The Roundway

Proposed Highway Works

Stage 1 Road Safety Audit

Ref: 2290-RSA-01

Problem Location Plan

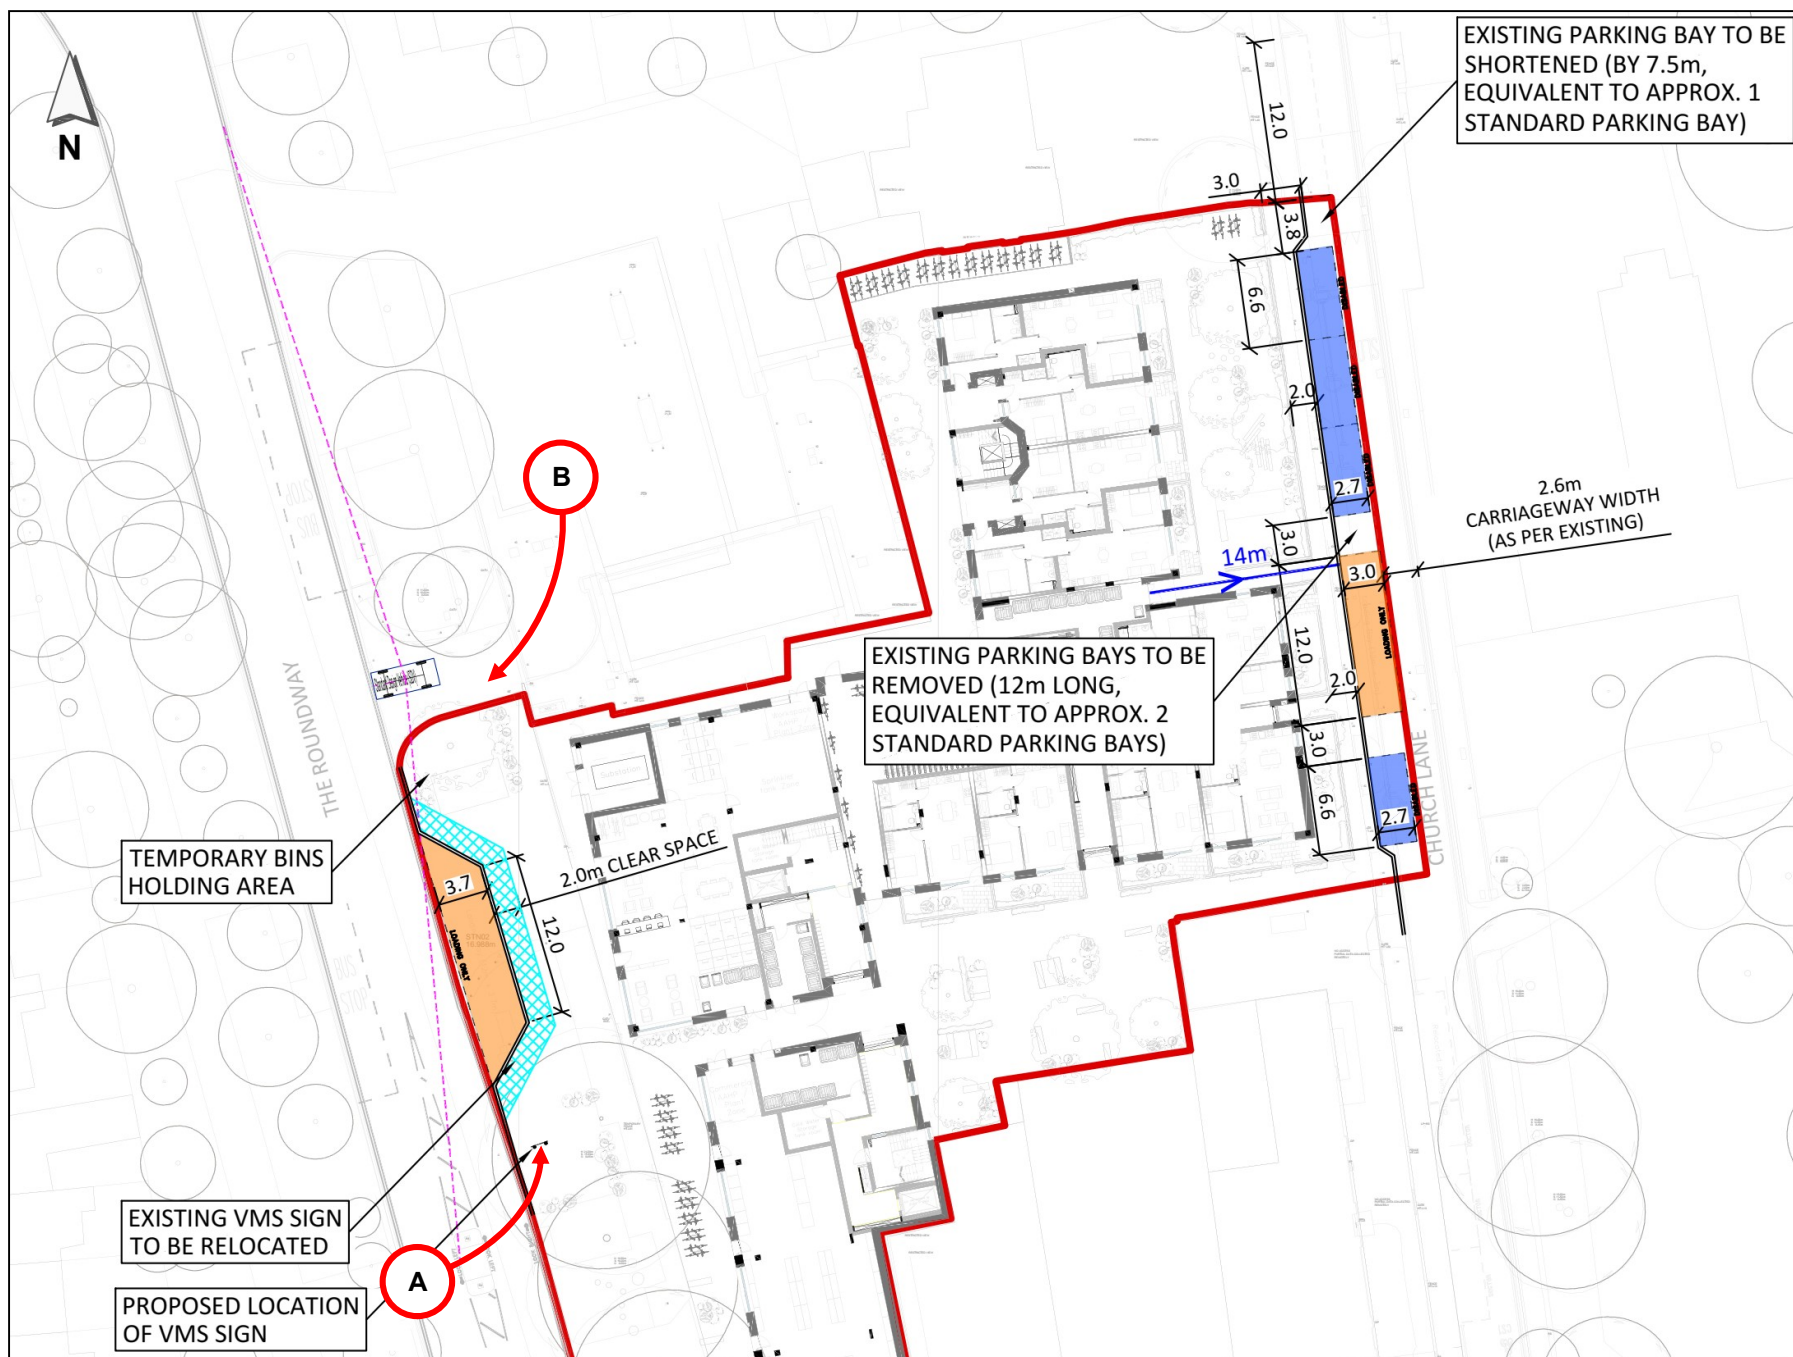
Location: A – Relocated VMS.

Summary: Increased risk of bridge strikes.

The scheme will relocate an existing VMS southwards in order to accommodate the proposed loading bay. The VMS, an overheight vehicle sign, will be located within the spread of a mature tree's canopy. As such, there is concern that the message displayed by the sign, or its detection function may be compromised. This may increase the risk of bridge strikes.

The message displayed by the VMS and its detection function should not be compromised by the tree canopy.

Location: B – Filling station exit onto The Roundway.

Summary: Revised geometry may constrain long vehicle movements.

Vehicles exiting the filling station routinely traverse the expansive northern crossover. This crossover is to be removed. Hence, there is concern that the movements of larger vehicles, such as articulated petrol tankers, may be unduly constrained when rejoining The Roundway. This could increase the risk of such vehicles oversweeping pedestrian surfaces and colliding with anyone present. Alternatively, such vehicles could oversweep the opposing traffic lane, increasing the risk of sideswipe collisions with opposing traffic.

Adequacy of the revised filling station exit geometry should be verified using swept path plots.
